Emergency Amendment Responses

Meliadine Mine – Water Licence 2AM-MEL1631

Nunavut Water Board

Agnico Eagle Mines Limited – Meliadine Division

D-CP1 AS-BUILT
KEY TRENCH AND DIKE LAYOUT PLAN

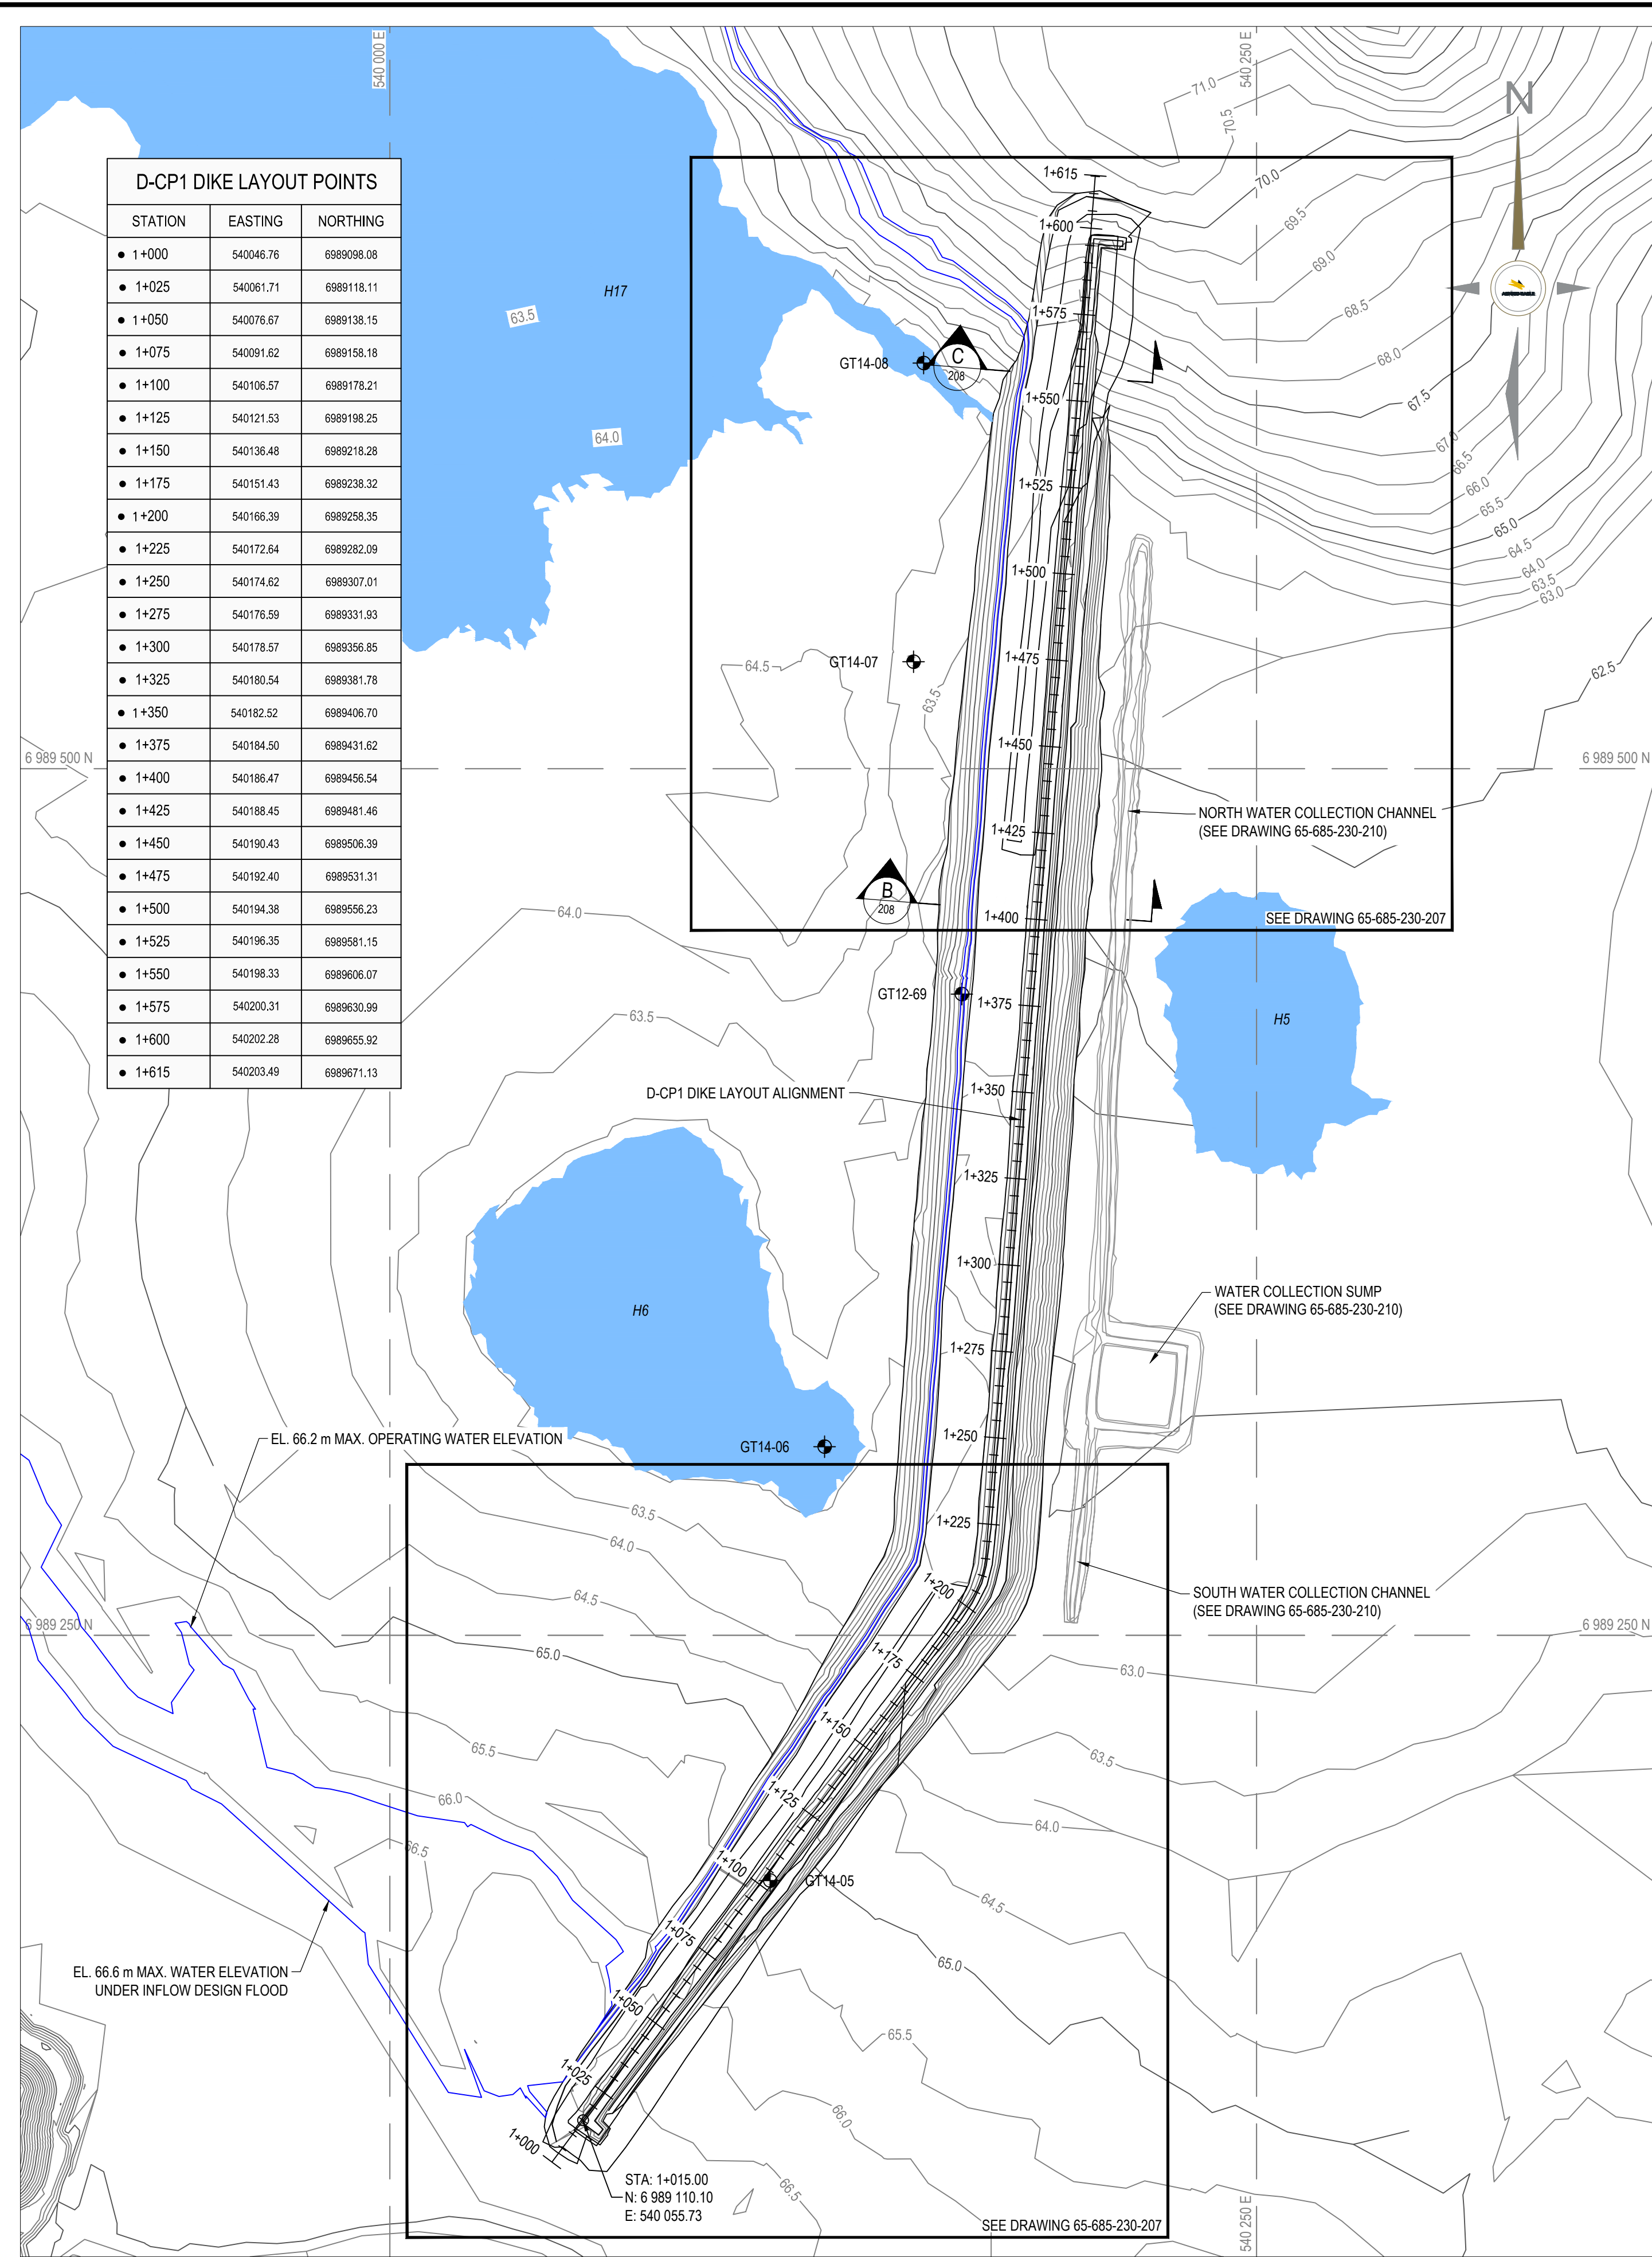
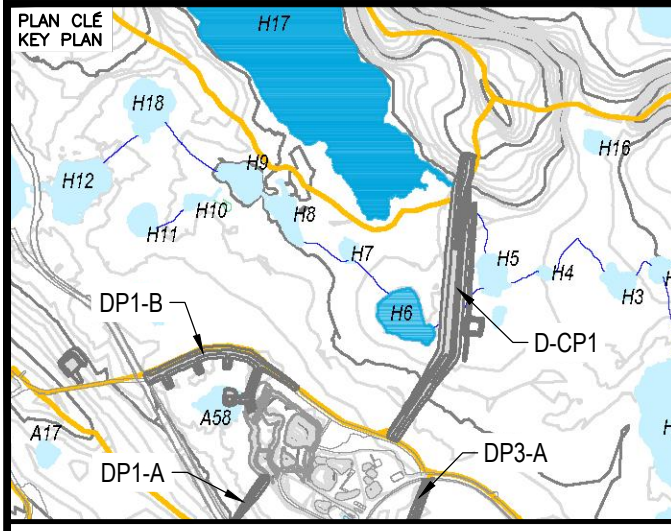
Note, that the original ground close to the south end of D-CP1 is flat and has a natural ground elevation slightly above 66.6 m as shown in Drawing 65-685-230-205 in Appendix B. Therefore, if the CP1 water elevation is higher than 66.6 m, then CP1 water could flow into the P2/P3 containment area or by-pass the dike south abutment and then flow down along the D-CP1 dike downstream toe into the downstream channel and sump. Site infrastructure may impact where water will flow as the water level rises above elevation 66.6 m.
